**ADDENDUM NO. 001**

**RE:** Sullivan County Department of Education – Emmett Elem. School Partial Roof Replacement  
T&L Project No. 17117

**DATE:** March 3, 2023

4 REGLET DETAIL  
A102 NOTE: VERIFY WEEP VENT LOCATION AND DO NOT COVER.

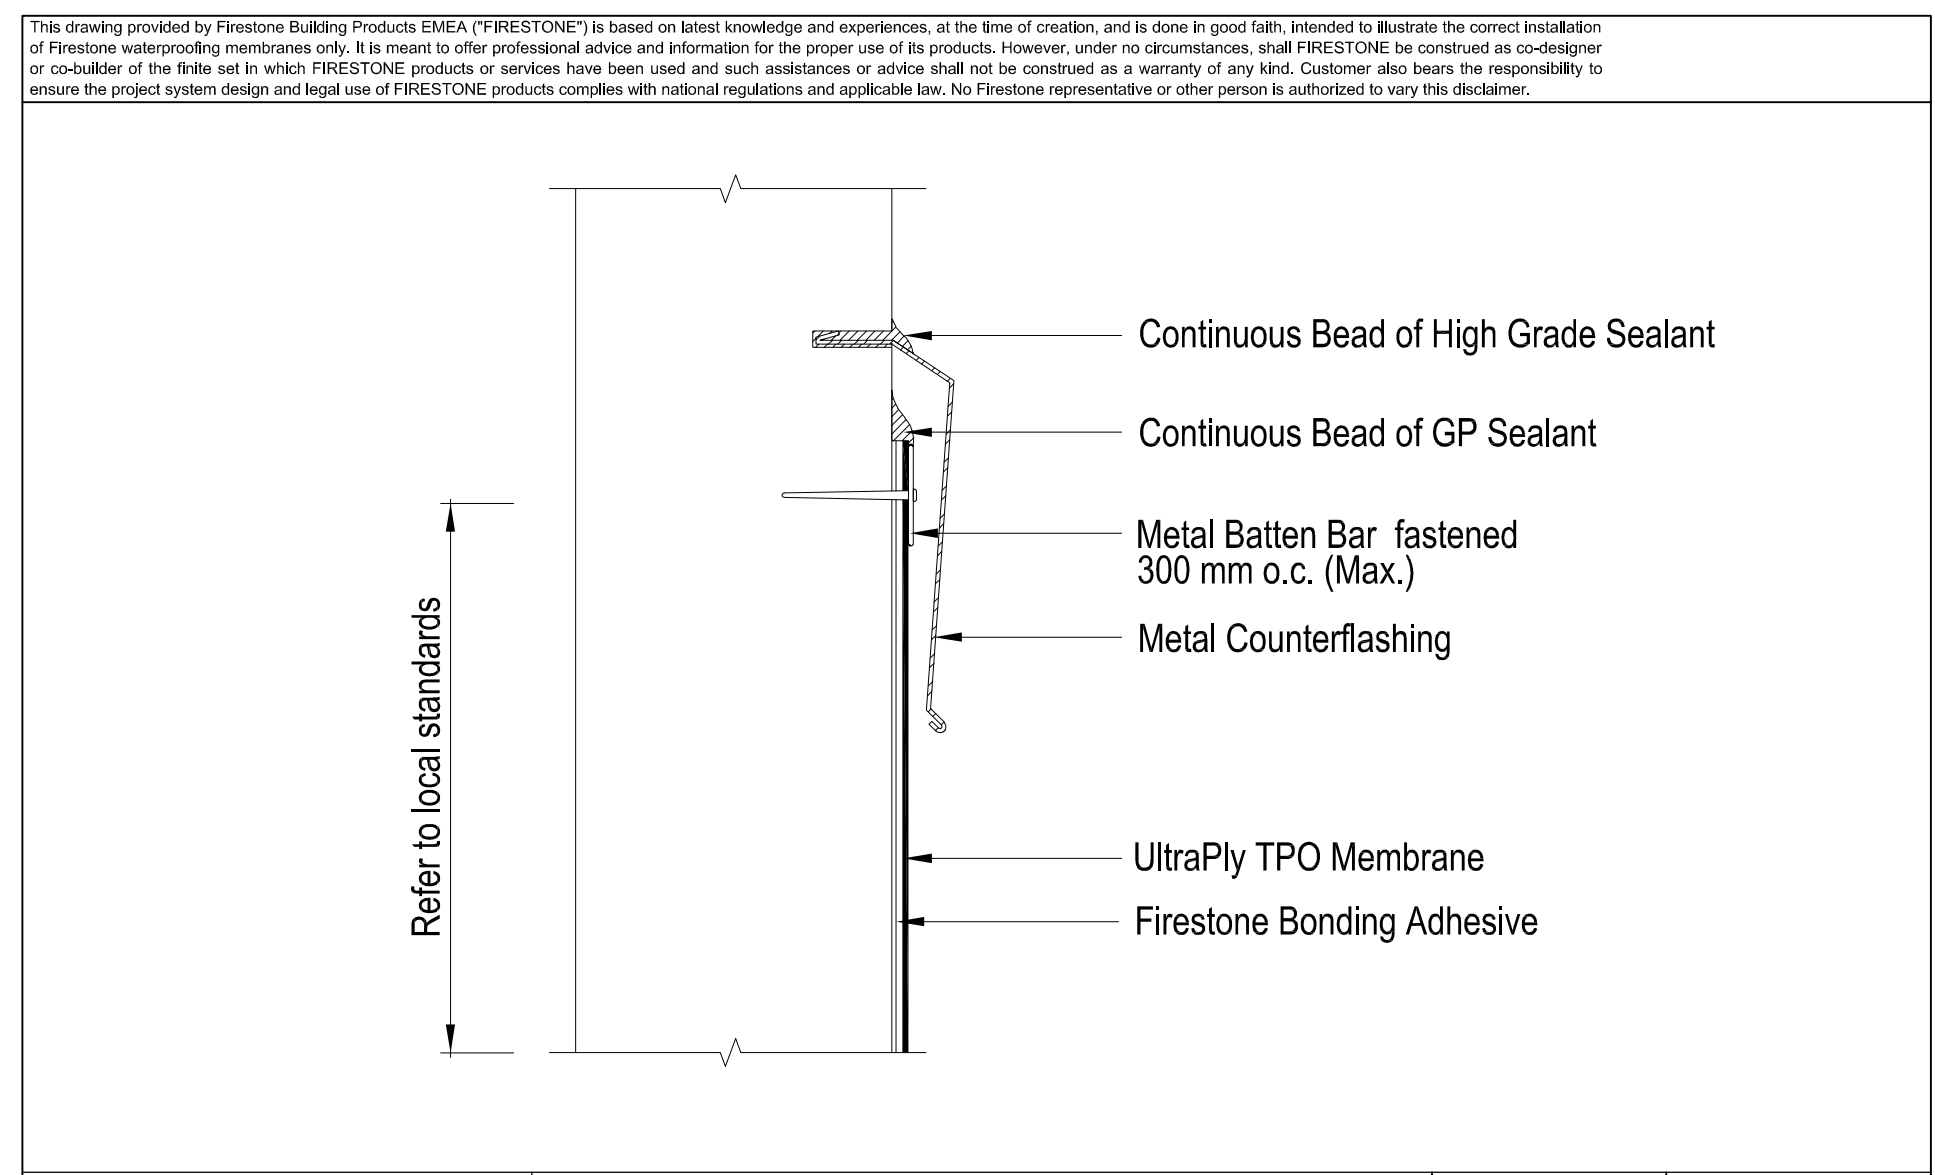
1. Drawing Sheets A102 revised note.

No.	1	Purpose of Document Issue	ADDED BLOCKING NOTE
Date	3/3/2023

NOTE: PROVIDE BLOCKING FOR ROOF EDGE AS REQUIRED.
